CITY OF PORTLAND, MAINE

HISTORIC PRESERVATION BOARD

HISTORIC PRESERVATION BOARD MEETING

- i. Preliminary Review of Revised Design Proposal for New Construction, 76 Congress Street (site of former St. Lawrence Church sanctuary); Friends of the St. Lawrence Church, Applicant.
- ii. Preliminary Review of Proposed Alterations, 9 Bowdoin Street; Barbara and Robert Burgess, Applicants.

THEATER: 5,715 GSF
PARISH HALL: 3,360 GSF +
FOOT PRINT: 9,075 GSF

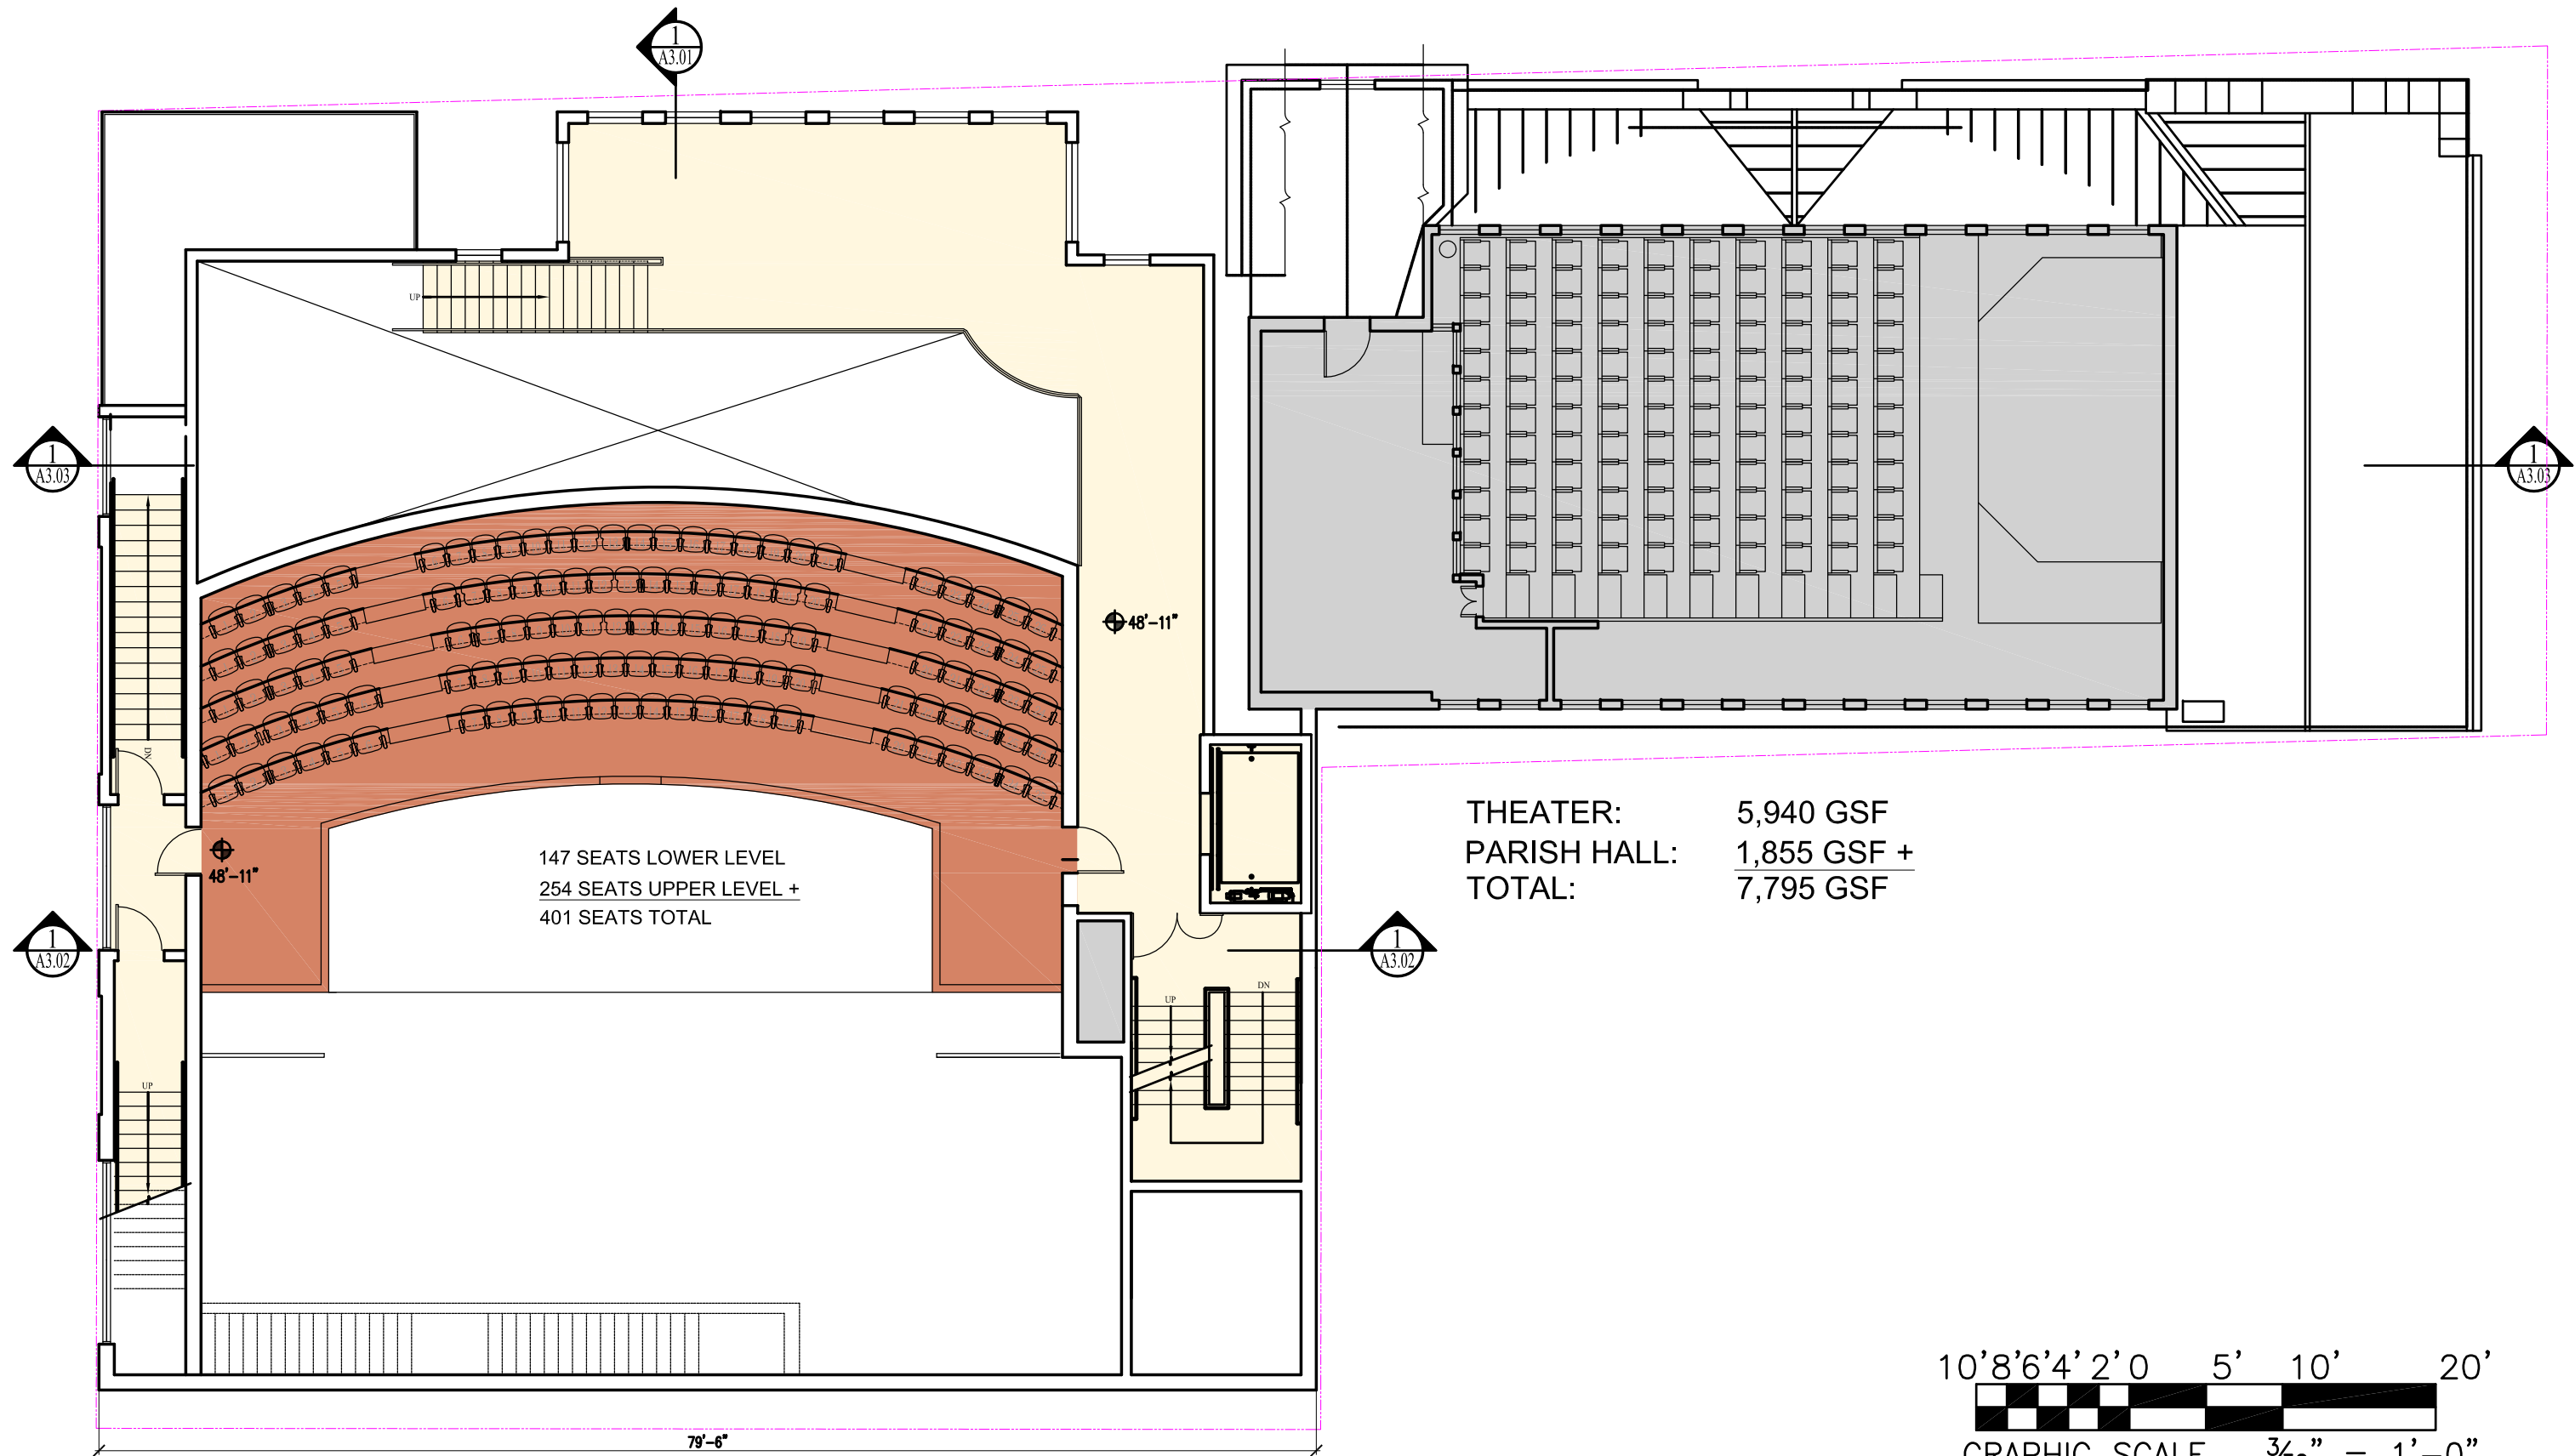
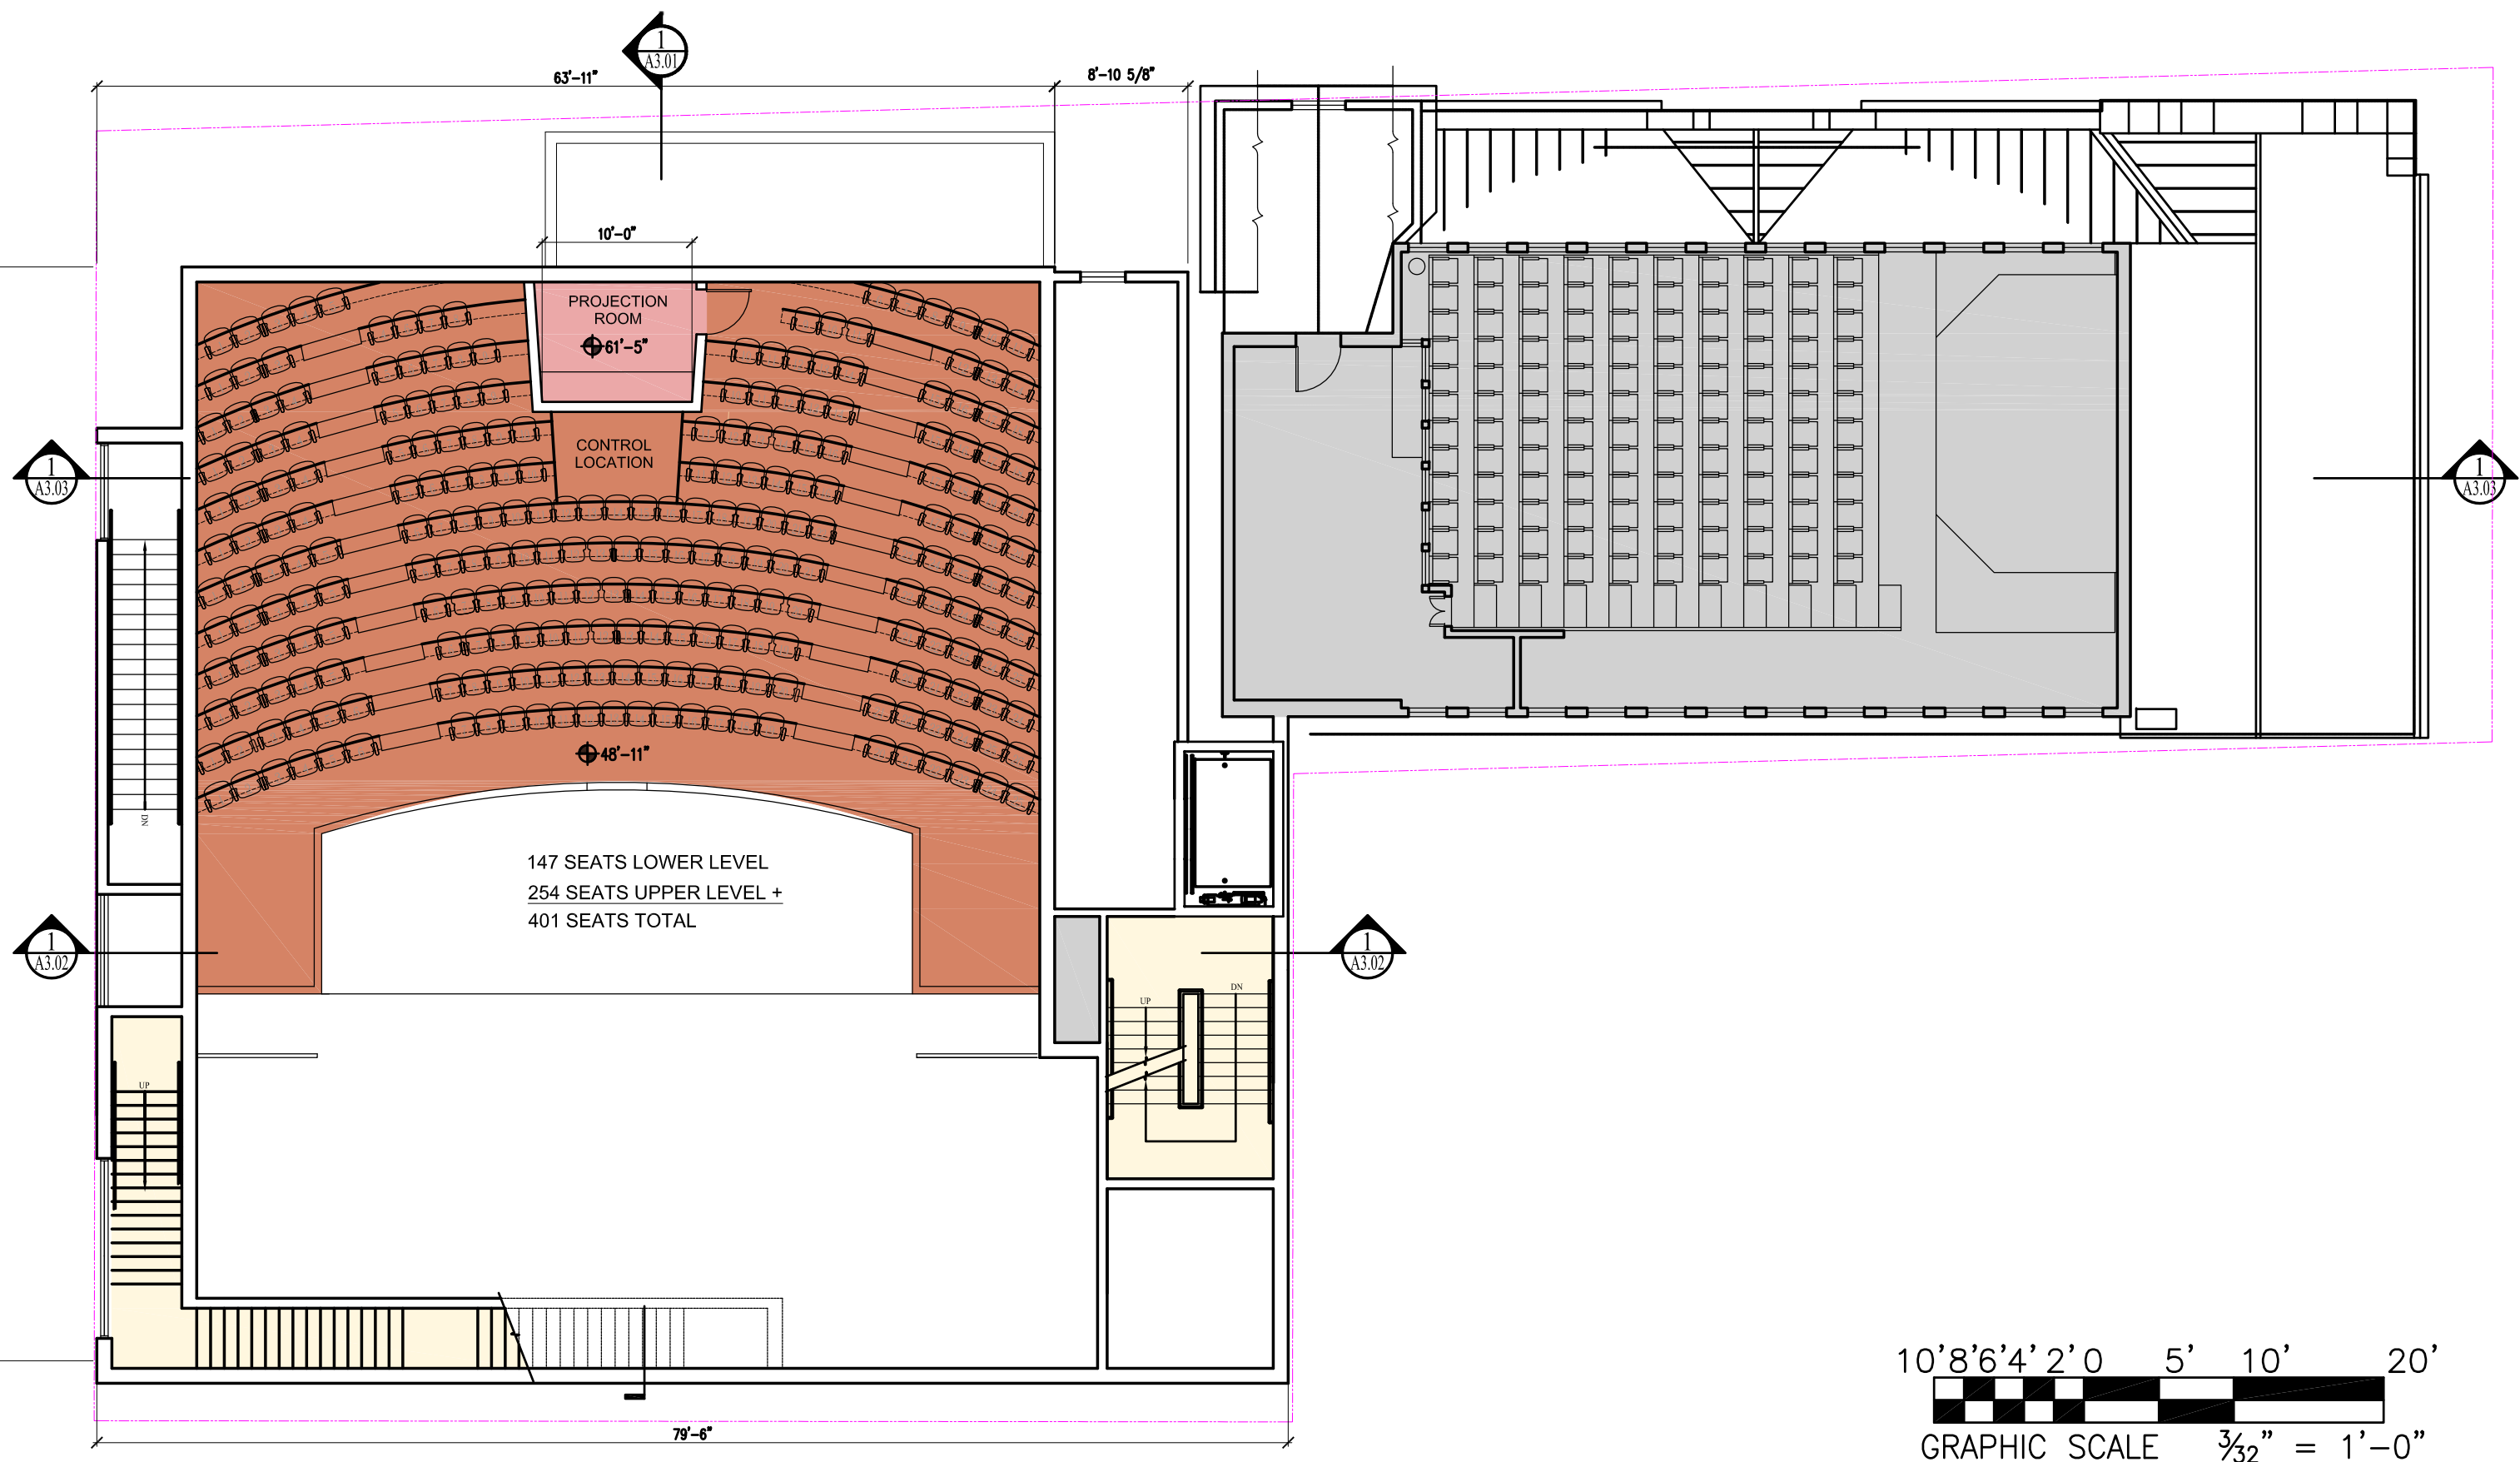
Architect David Lloyd, representing Friends of the St. Lawrence Church, has requested a workshop to present a design proposal for a new addition to the parish hall of the former St. Lawrence Congregational Church at 76 Congress Street. The addition will replace the former church sanctuary which was demolished in 2008.

Note that the enclosed design proposal replaces a previous proposal for the addition that was presented to the Board in 2010. The goal of this preliminary workshop is to provide initial feedback to the applicant and architect on the general scale, massing and design expression of the proposed structure. The Friends of the St. Lawrence will need to embark on an ambitious fundraising campaign in order to build a new arts facility adjoining St. Lawrence's existing parish hall and want to gauge the Board's relative support for the proposed design direction before they present the plans as part of their fundraising initiative.

As Mr. Lloyd states in his letter, the organization received feedback from potential funders that their plans to replicate the original exterior would be inordinately expensive, boosting the overall project costs enormously. Based on this input, the Friends elected to rethink their original plans and hired a new architect to provide design assistance.

recessed and features a glass curtain wall. An elevated plaza is located in front of the recessed glass wall. The upper floor of the building appears to be a sheer-walled rectilinear box. According to the project architect, a perforated metal skin is being considered for the exterior siding. Lighting is also being explored for behind the skin. The top floor, which is set back slightly from Congress Street and considerably from Munjoy Street, is a 10' tall glass-walled space. As planned, it will function as a community meeting room.
